GIRDWOOD TRAILS PLAN

RE: GTP Public Review Draft

Recommended Changes

October 5, 2021

NS1: Virgin Creek Natural Space

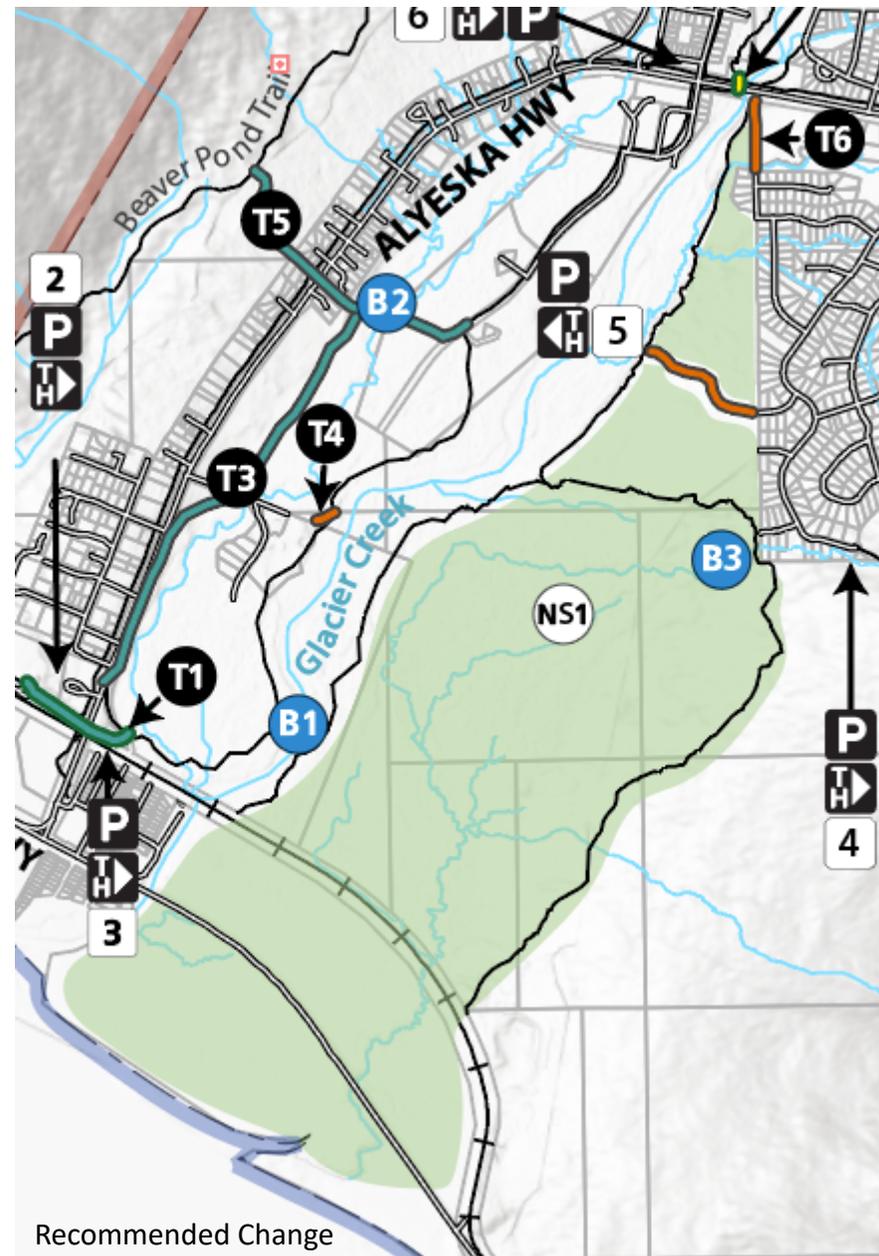
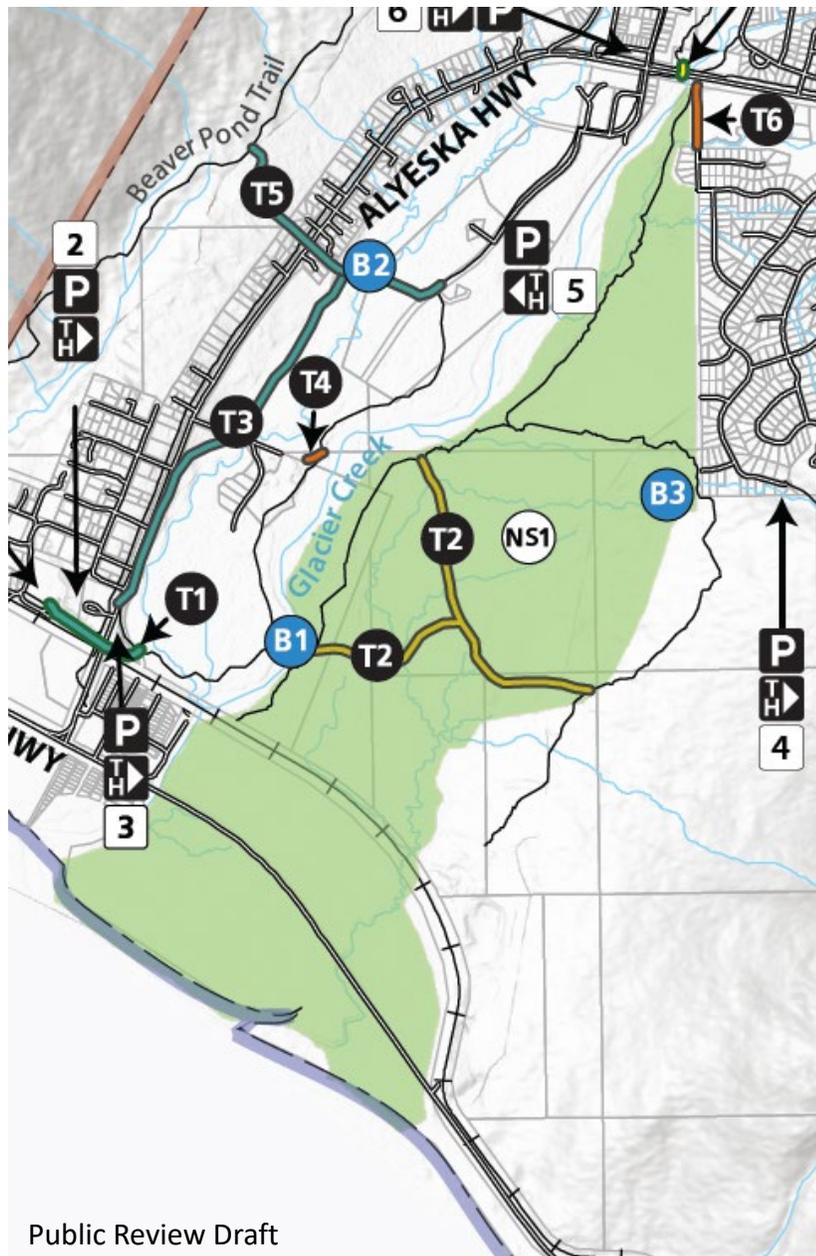
Recommend adjusting the boundary of NS1. The eastern boundary should extend and include the Wagon Trail. The western boundary should be adjusted to remove the Joe Danich Trail from NS1. ADD a trail project to the plan that brings the Joe Danich up to a Class 3 trail constructed to the bicycle design parameter and relocate out of wetlands to uplands. ADD trail project to the plan to construct neighborhood connector trail (Class 3, bicycle design parameters, constructed in uplands) from the Turin and/or Carlina Drive cul-de-sacs to connect to the Joe Danich trail. NS1, with the adjusted boundary, remains non-mechanized with trails that are no greater than Class 2. **WHY:** Comments indicate that residents want a multi-use alternative trail to connect from the lower valley to the upper valley without using the road system. A Class 3 designation provides a sustainable connection to neighborhoods. The eastern boundary shift better aligns with a primitive experience for the Wagon Trail.

MB1: Beaver Pond MB Area

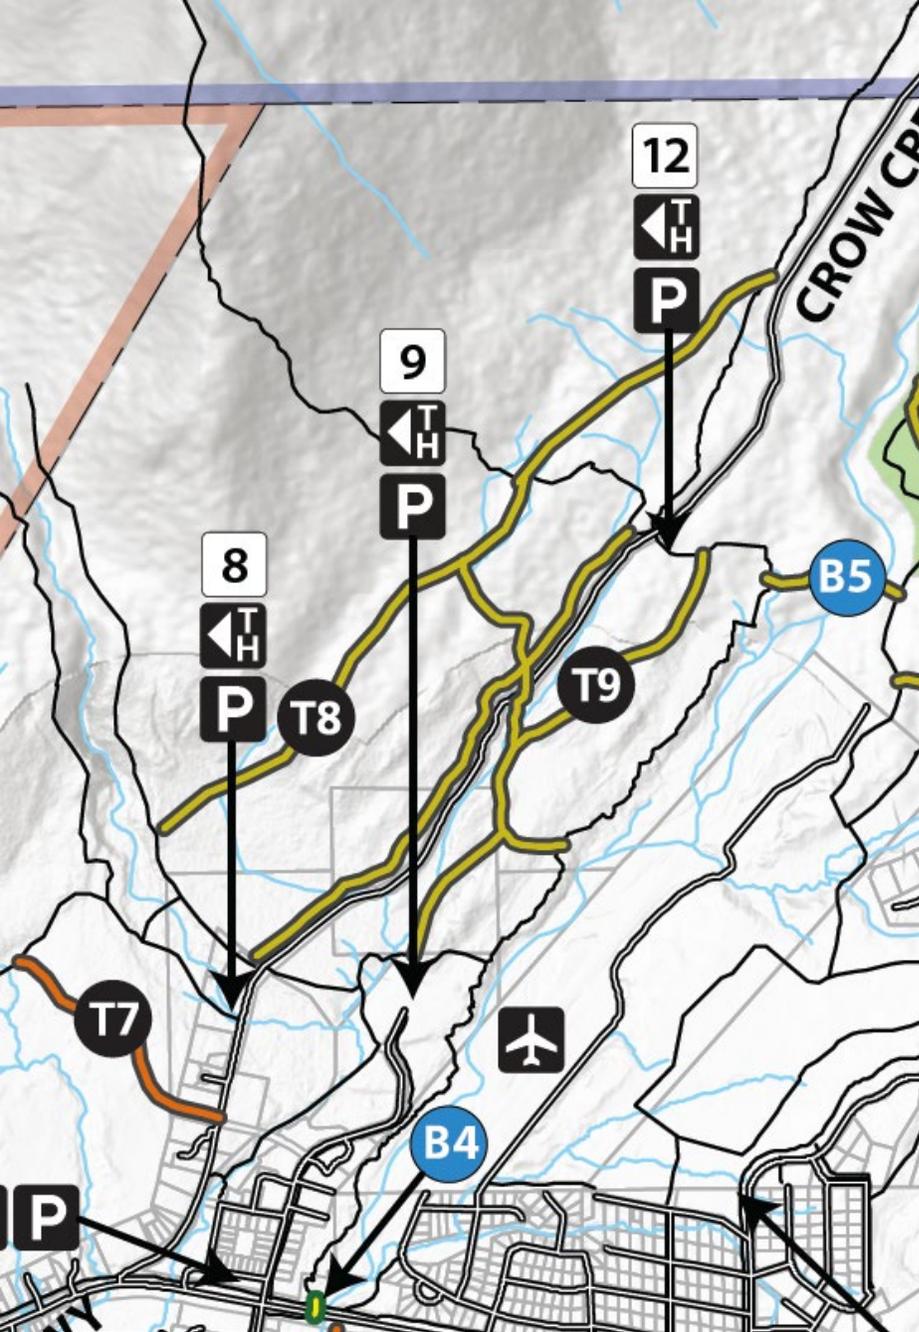
Recommend removing MB1 from the plan. **WHY:** There is not consensus about this project. Needs more discussion – if included in the plan MB1 shall be developed in consultation with the Girdwood Trails Committee only after MB2 is complete. If MB1 is removed, user conflicts on Abe’s and California Creek Trails still needs to be addressed.

NS2: Stumpy’s Natural Space

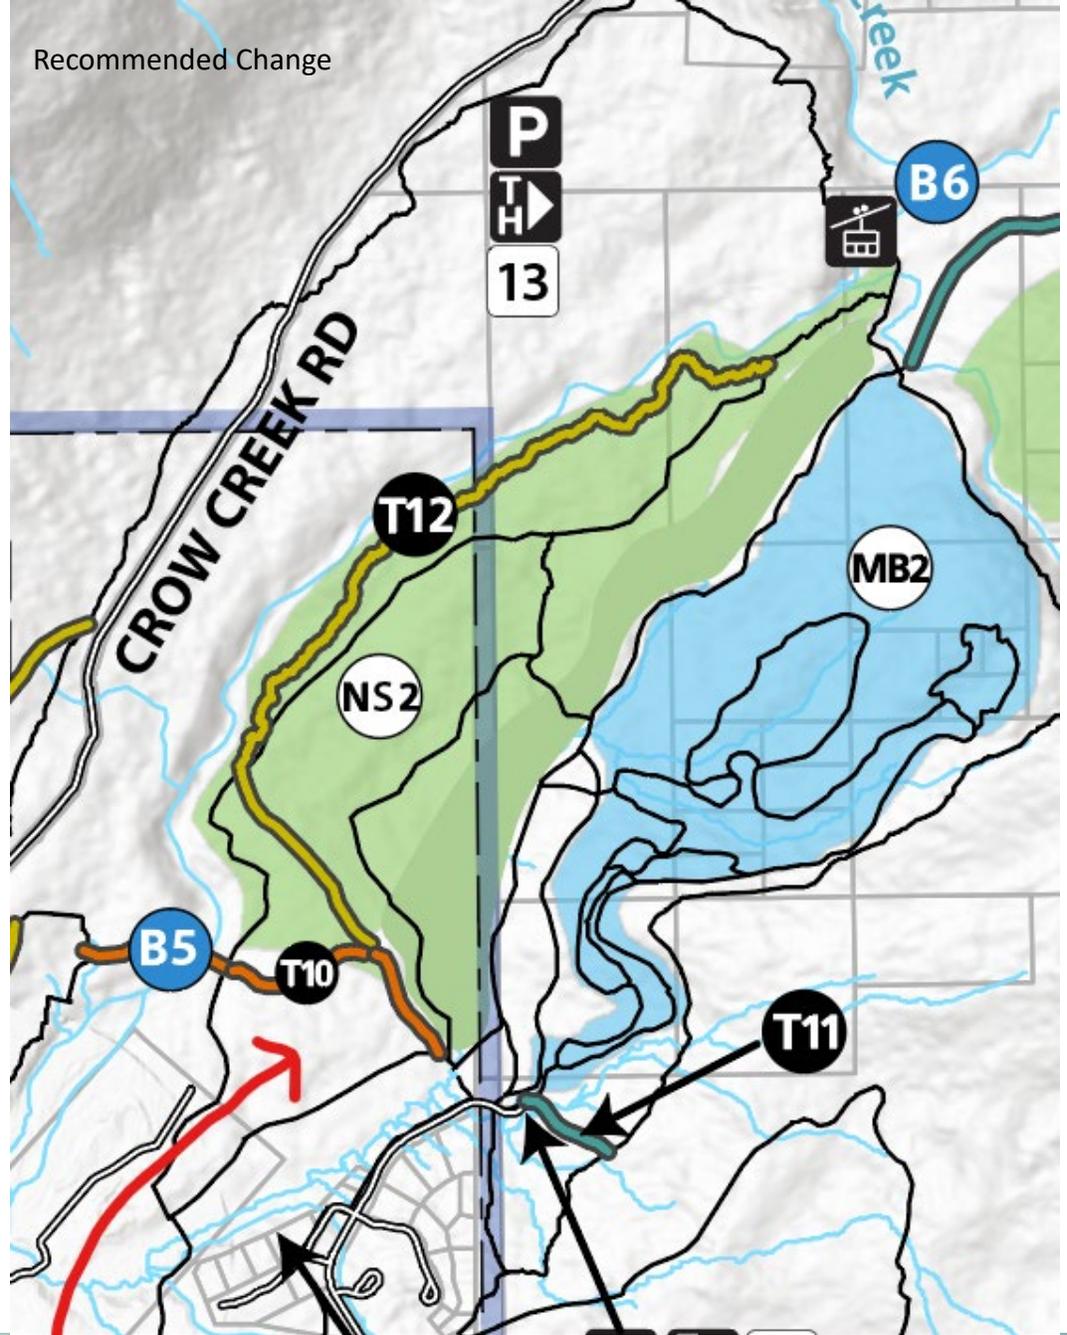
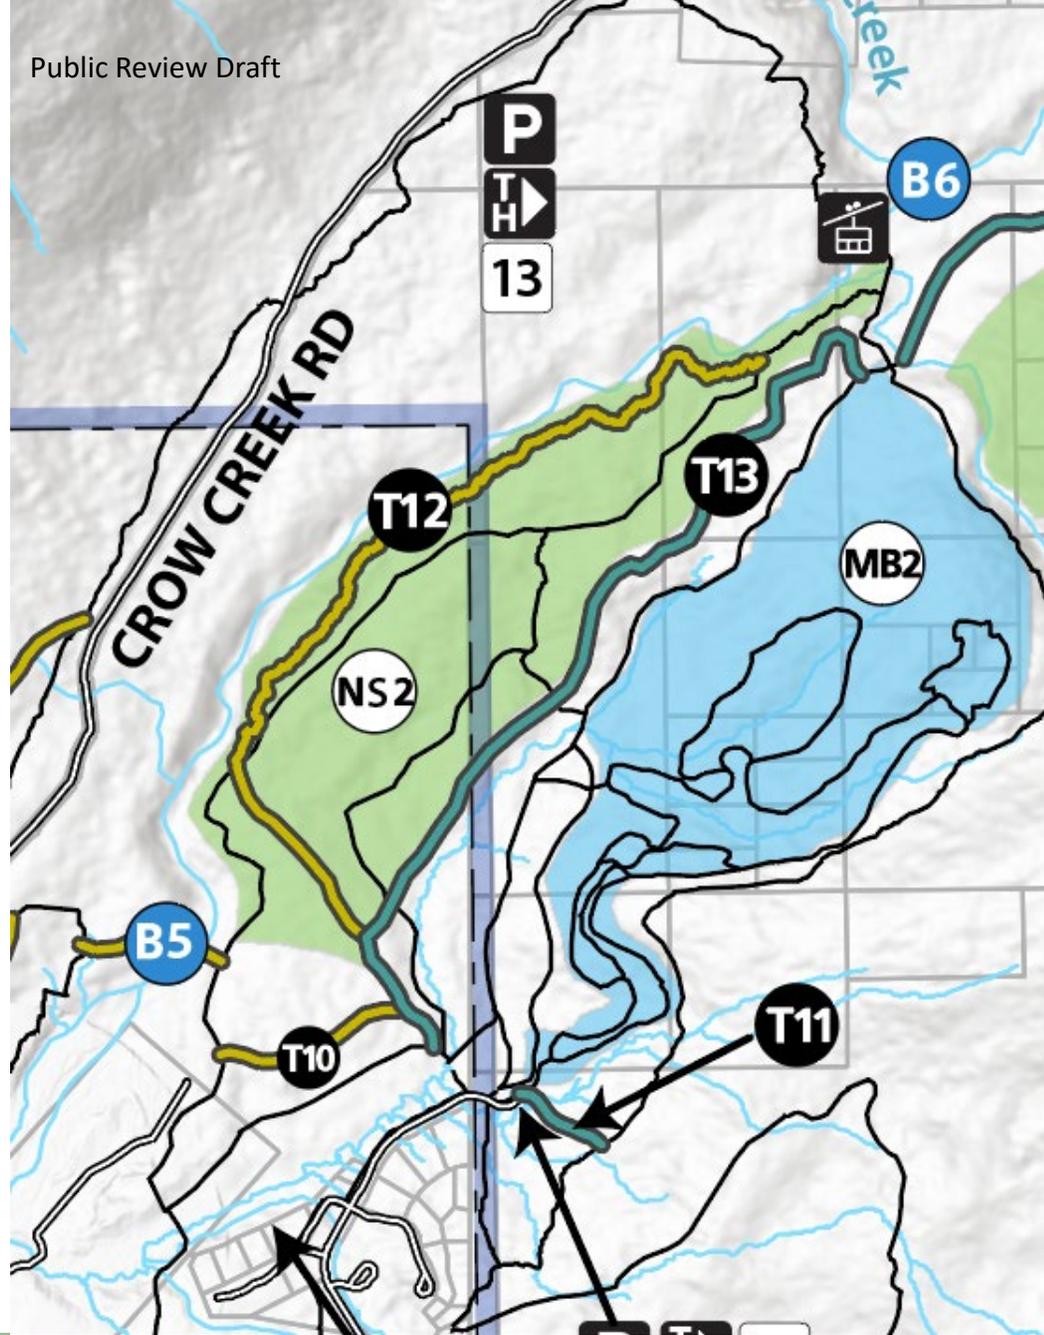
Recommend adjusting the boundary of NS2. Expand the boundary to the east to extend up to but not including the Snowcat Trail and the groomed section of Stumpy’s winter trail. **WHY:** There isn’t consensus for T13 and the wetlands are better suited for a more primitive experience.

NS1: Virgin Creek Natural Space

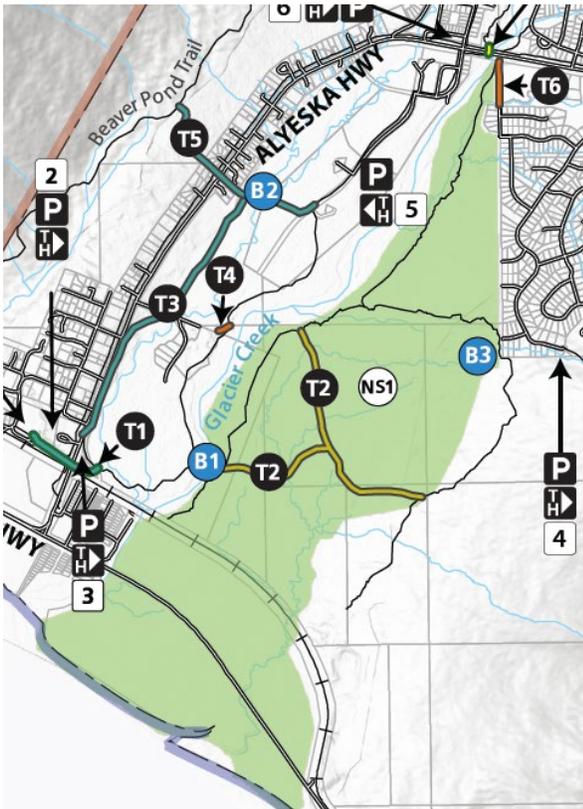
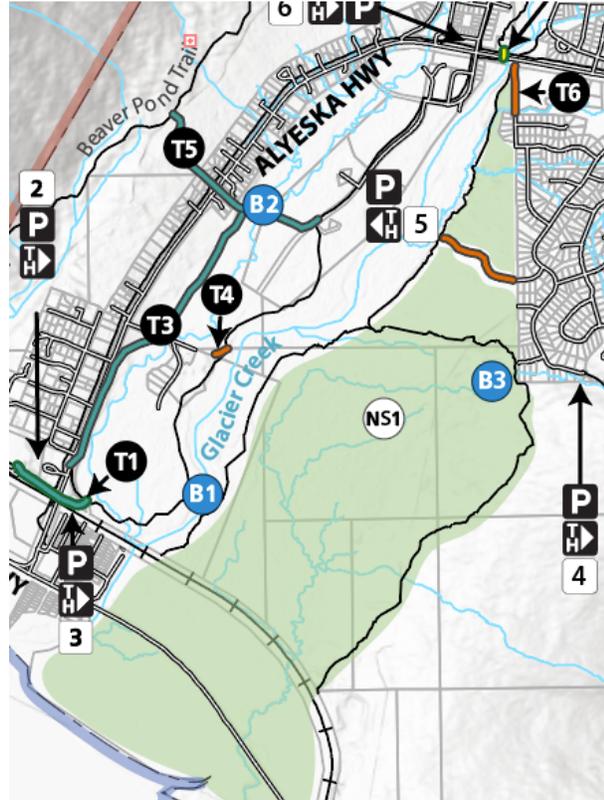
Recommend adjusting the boundary of NS1. The eastern boundary should extend and include the Wagon Trail. The western boundary should be adjusted to remove the Joe Danich Trail from NS1. ADD a trail project to the plan that brings the Joe Danich up to a Class 3 trail constructed to the bicycle design parameter and relocate out of wetlands to uplands. ADD trail project to the plan to construct neighborhood connector trail (Class 3, bicycle design parameters, constructed in uplands) from the Turin and/or Carlina Drive cul-de-sacs to connect to the Joe Danich trail. NS1, with the adjusted boundary, remains non-mechanized with trails that are no greater than Class 2. Comments indicate that residents want a multi-use alternative trail to connect from the lower valley to the upper valley without using the road system. A Class 3 designation provides a sustainable connection to neighborhoods. The eastern boundary shift better aligns with a primitive experience for the Wagon Trail.

NS2: Stumpy's Natural Space

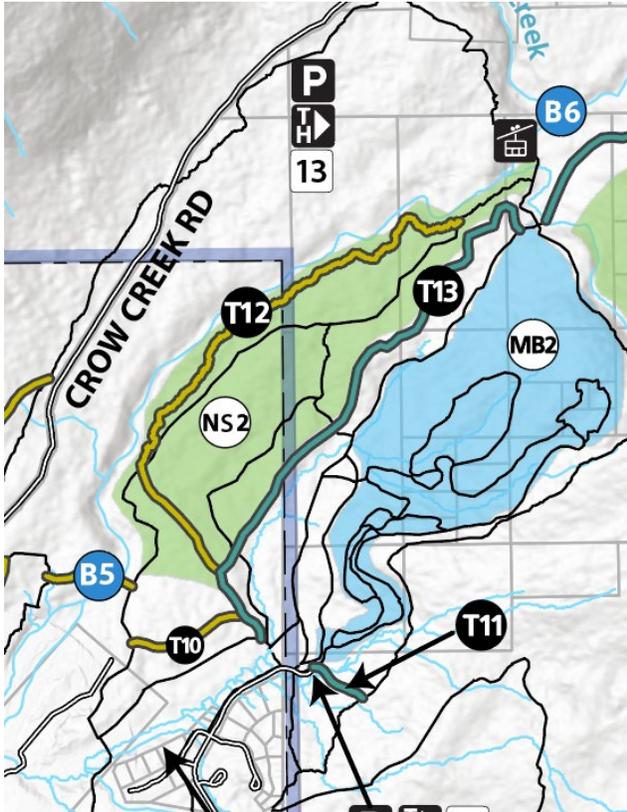
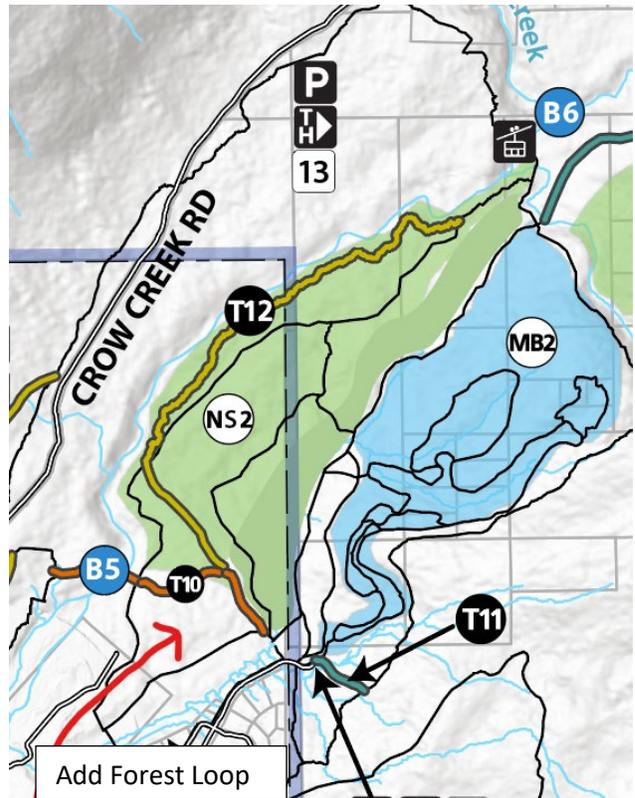
Recommend adjusting the boundary of NS2. Expand the boundary to the east to extend up to but not including the Snowcat Trail and the groomed section of Stumpy's winter trail. (T13-Upper Valley Multi-Use Trail recommended to be removed from the draft plan and add Forest Loop back).

MB1: Beaver Pond MB Area

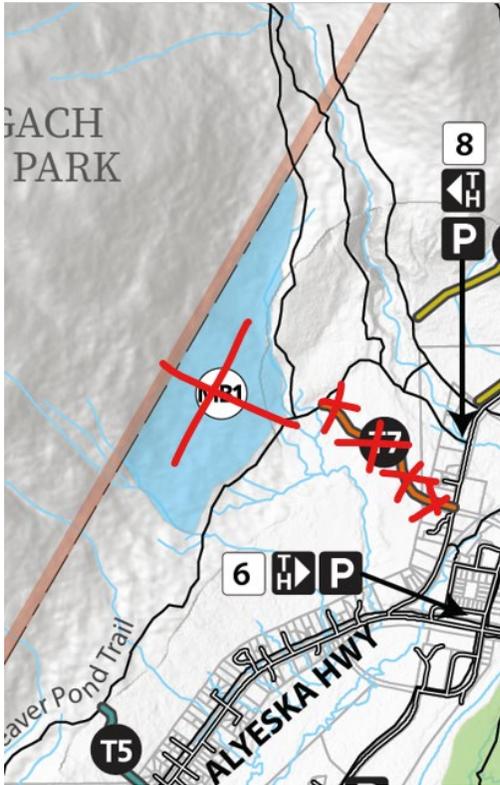
CHANGE RECOMMENDED – Remove MB1 from the plan:

There is not consensus about this project. Needs more discussion – if included in the plan MB1 shall be developed in consultation with the Girdwood Trails Committee only after MB2 is complete. If MB1 is removed, user conflicts on Abe's and California Creek Trails still needs to be addressed.
